RE: North Florida-Southeast Georgia (NFSEG) Regional Groundwater Flow Model

Review Questions and Comments

Appendix A
Initial Review Questions and Comments
Liquid Solutions Group, LLC
May 27, 2016

Appendix B
Preliminary Review Questions, Comments and Responses
Liquid Solutions Group, LLC
October 2015 to January 2016

Figure 1 – HSPF 2001 Rainfall

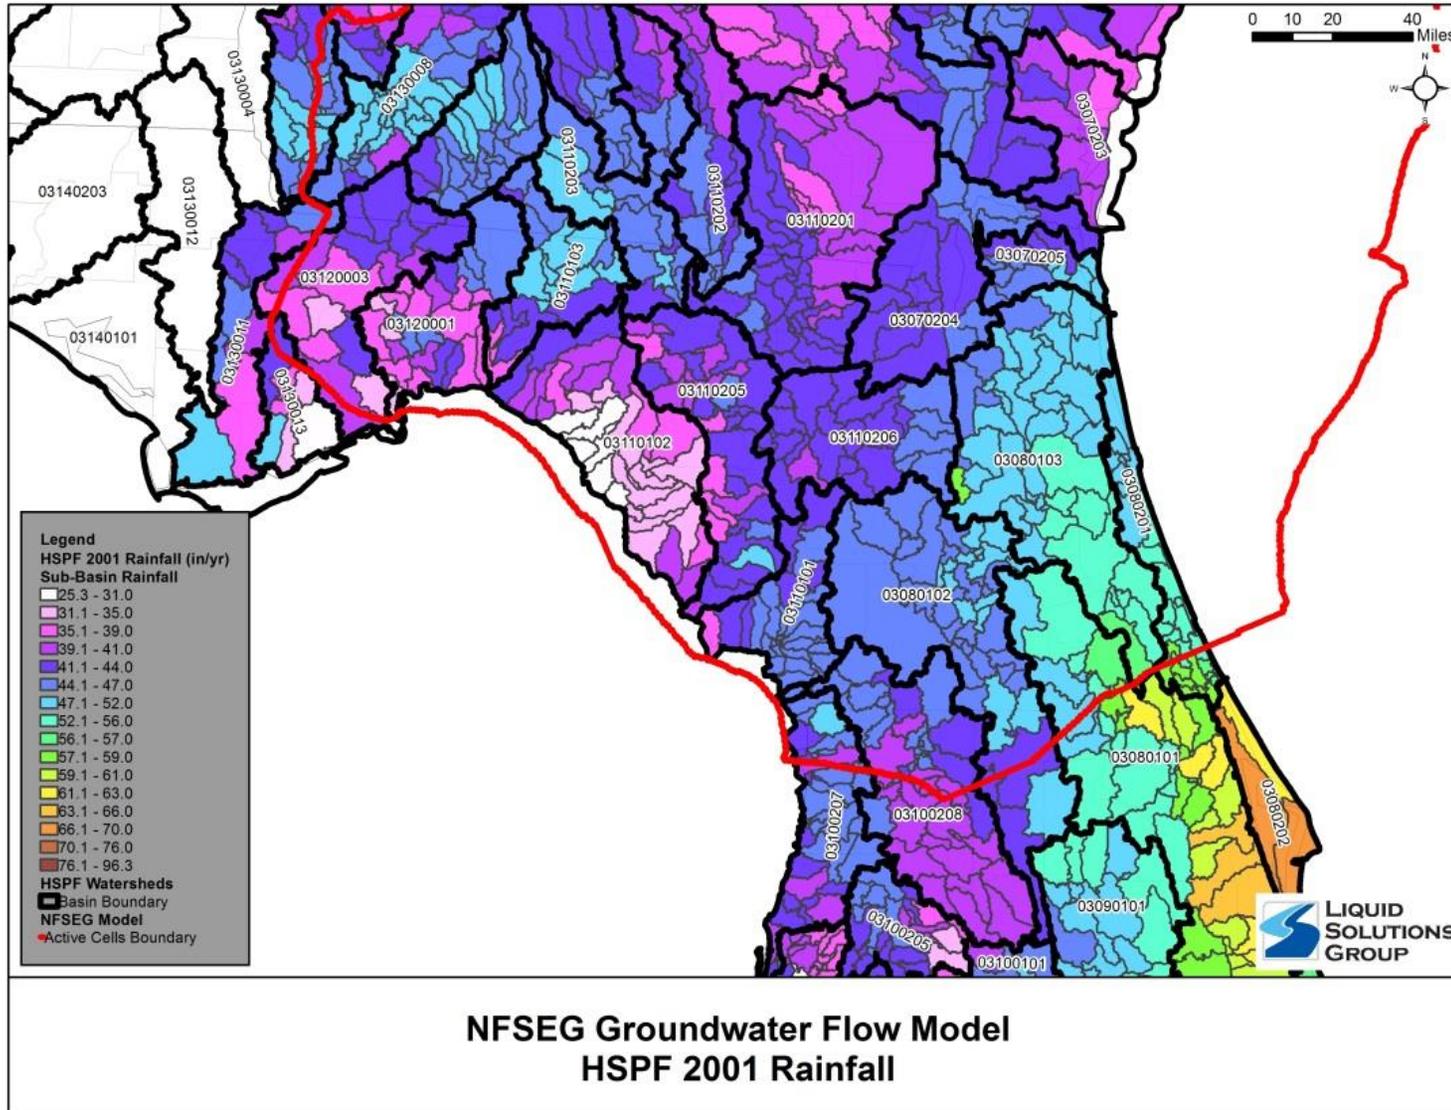
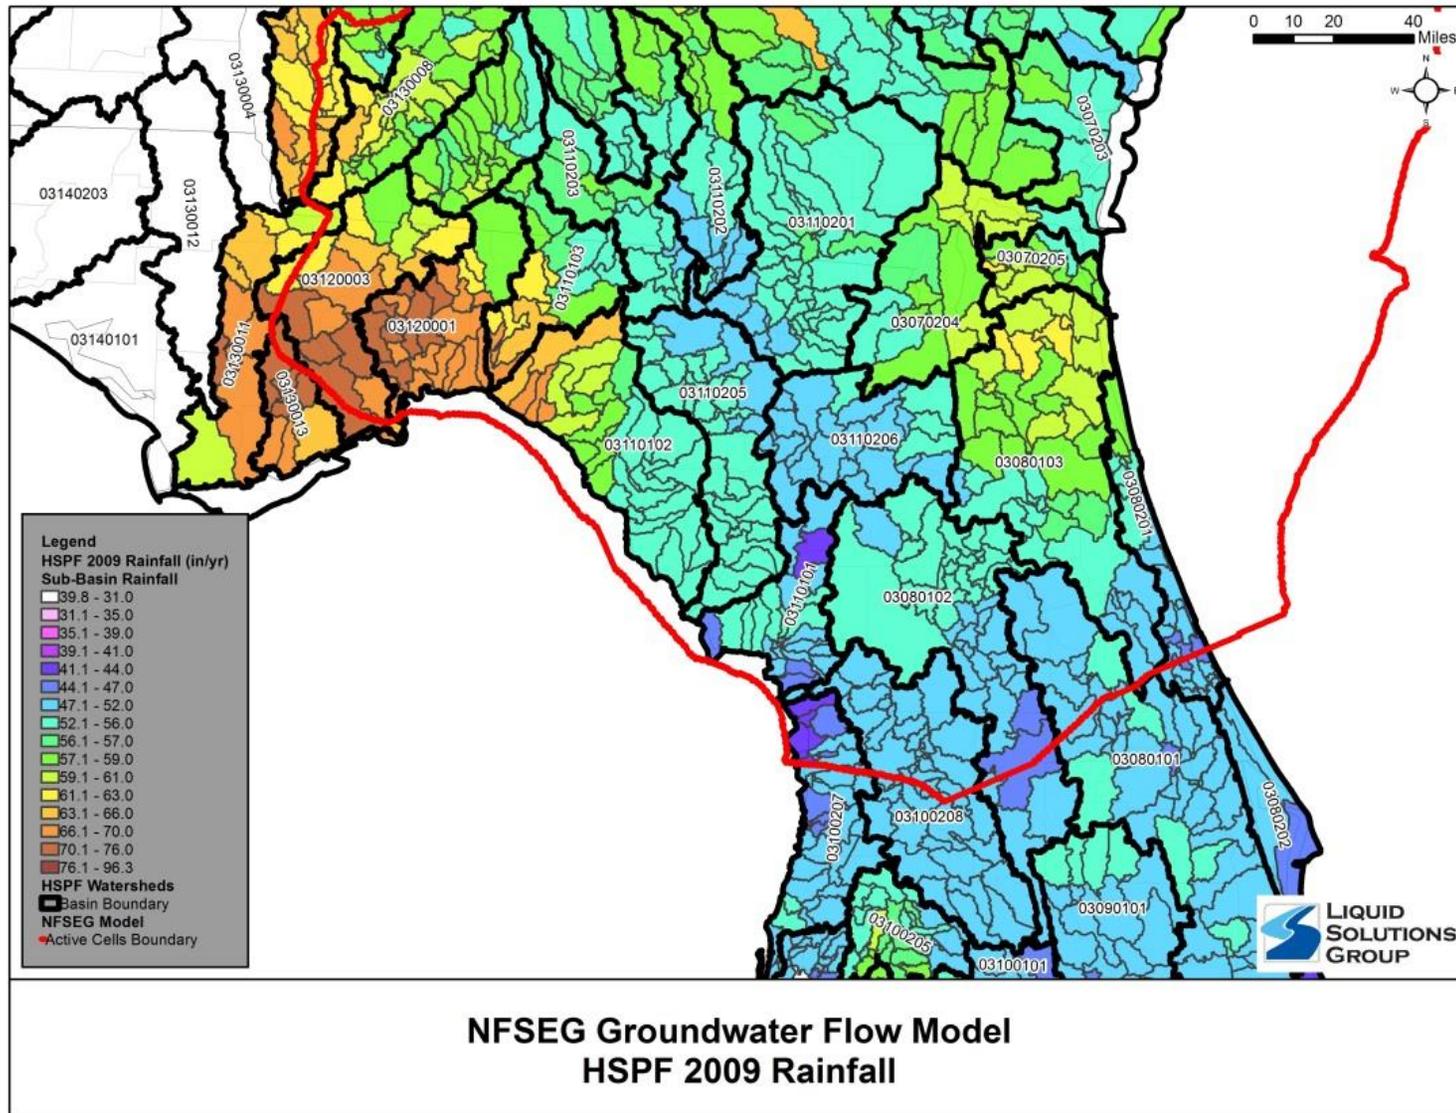
1. In previous comments, LSG identified an issue with incorrect rainfall input to one HSPF model. Because of this issue, LSG broadened its review of the rainfall input to the HSPF models. **Figure 1** and **Figure 2** depict 2001 and 2009 rainfall used in the HSPF Models. Based on this review, some areas appear to have higher or lower rainfall than anticipated. Please describe the source of rainfall data that was used in the HSPF models. Please provide a comprehensive analysis of how the data used for the HSPF models compares to other available sources of rainfall data, such as gage observations, for the area of the NFSEG Model? Please review and confirm the accuracy of the rainfall data used in the HSPF models.

Figure 3 – HSPF 2001 Calculated Recharge

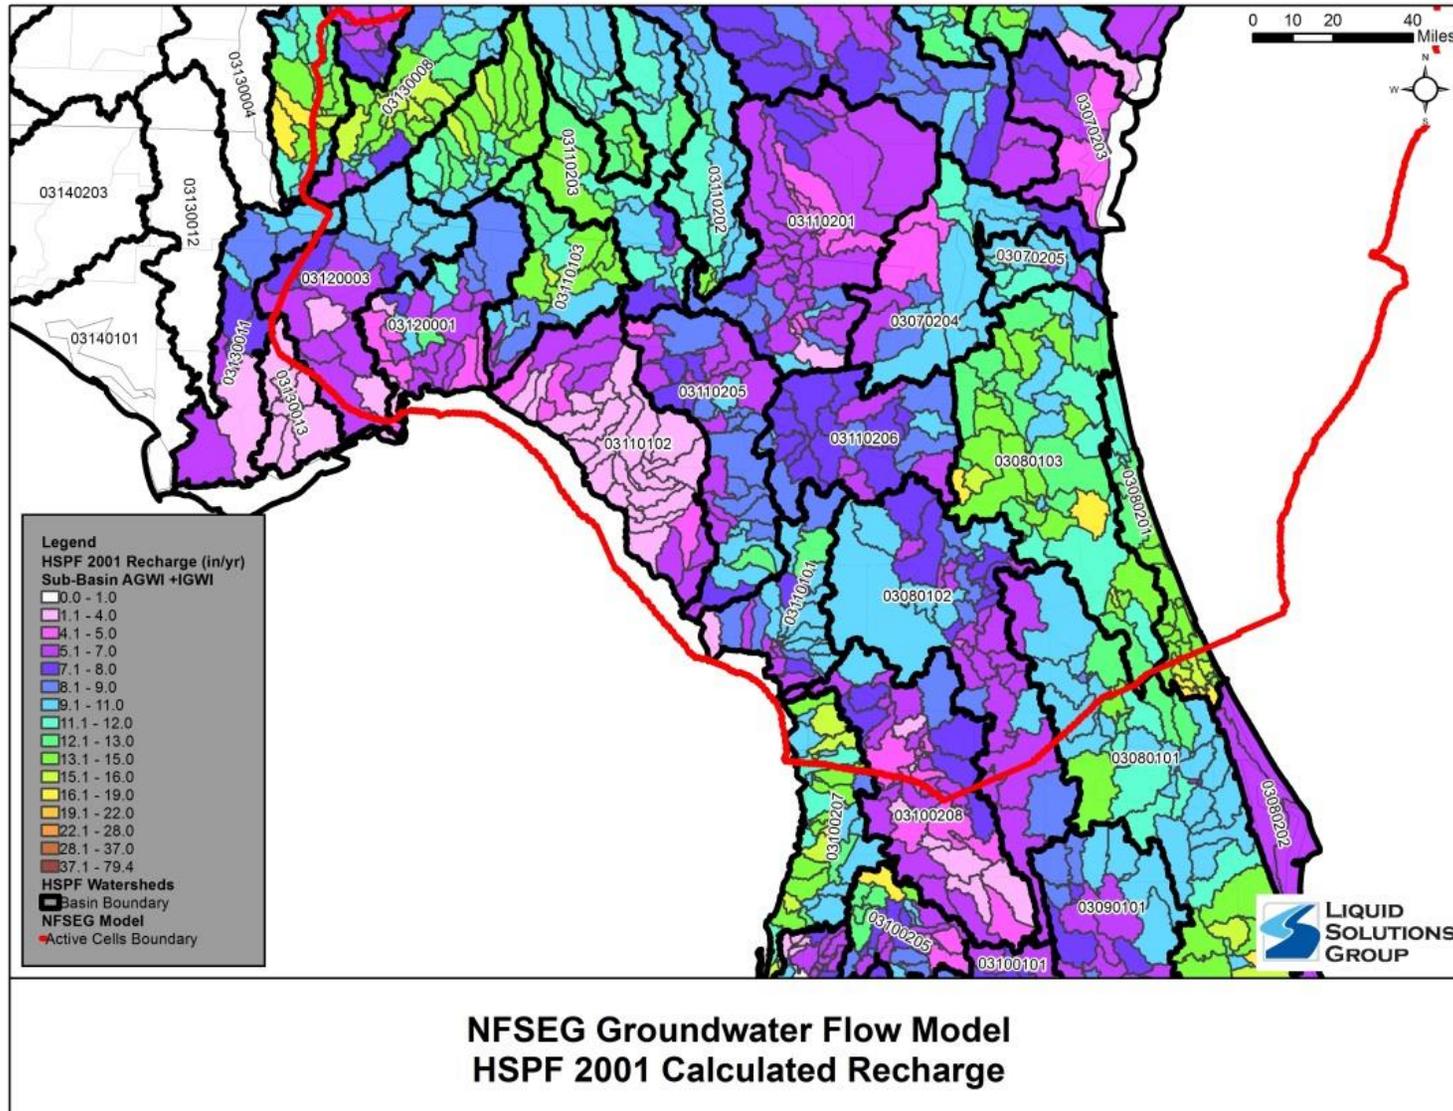
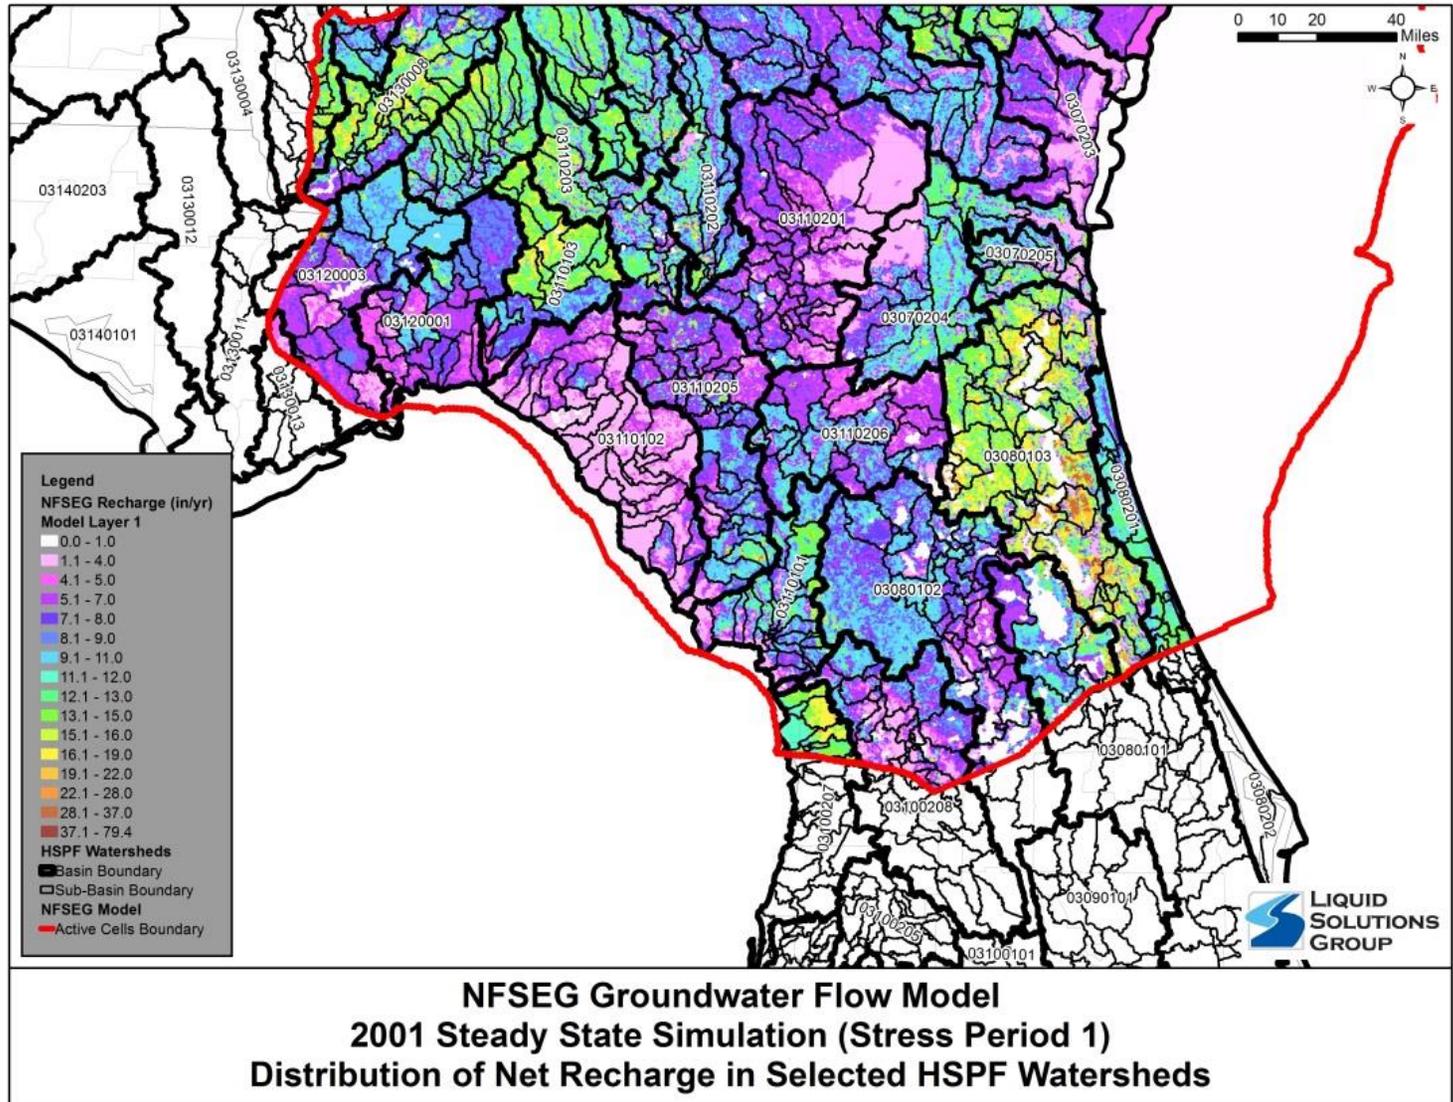
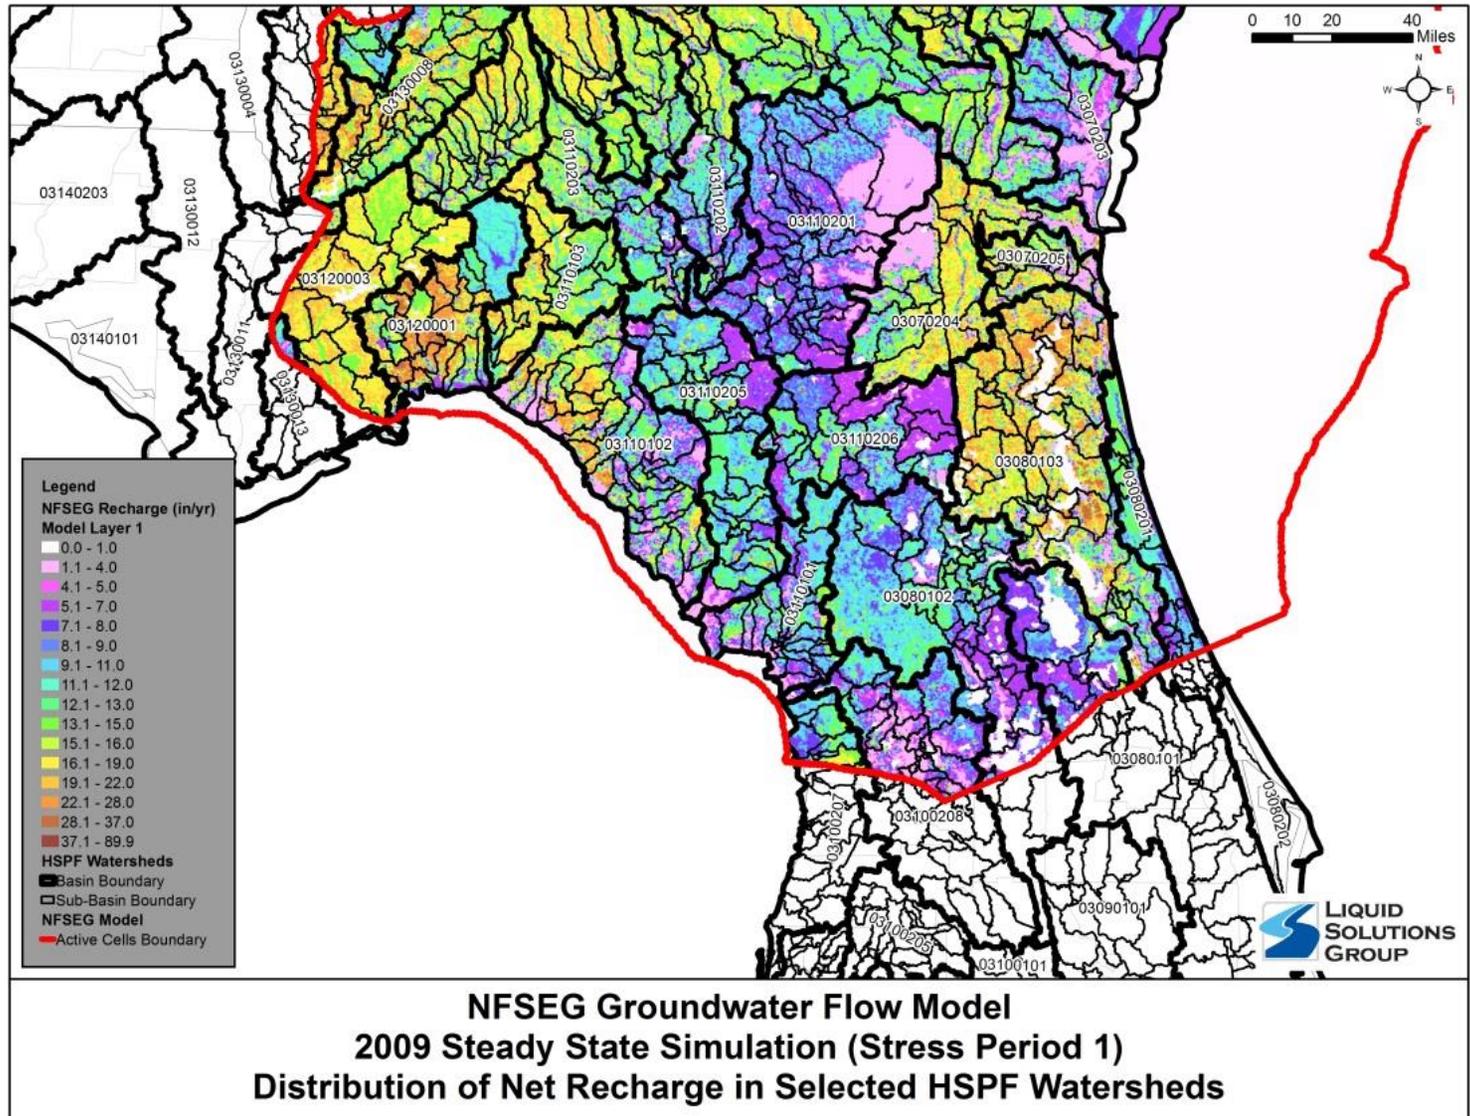
- **Figure 3:** 2001 HSPF calculated recharge by watershed and subwatershed
 - **Figure 4:** 2001 recharge assigned to the MODFLOW groundwater flow model

- **Figure 5:** 2009 HSPF calculated recharge by watershed and subwatershed
 - **Figure 6:** 2009 recharge assigned to the MODFLOW groundwater flow model

From these figures, discontinuities in recharge along HSPF model boundaries can be observed in other areas of the model. This result of HSPF means that two adjacent areas with similar land use, soil type, elevation, etc. on either side of an HSPF model boundary have been assigned notably different recharge values. This does not appear to be a reasonable representation of the physical system. We recommend a thorough evaluation of the model conceptualizations causing this issue and the development of a revised methodology to address this issue.
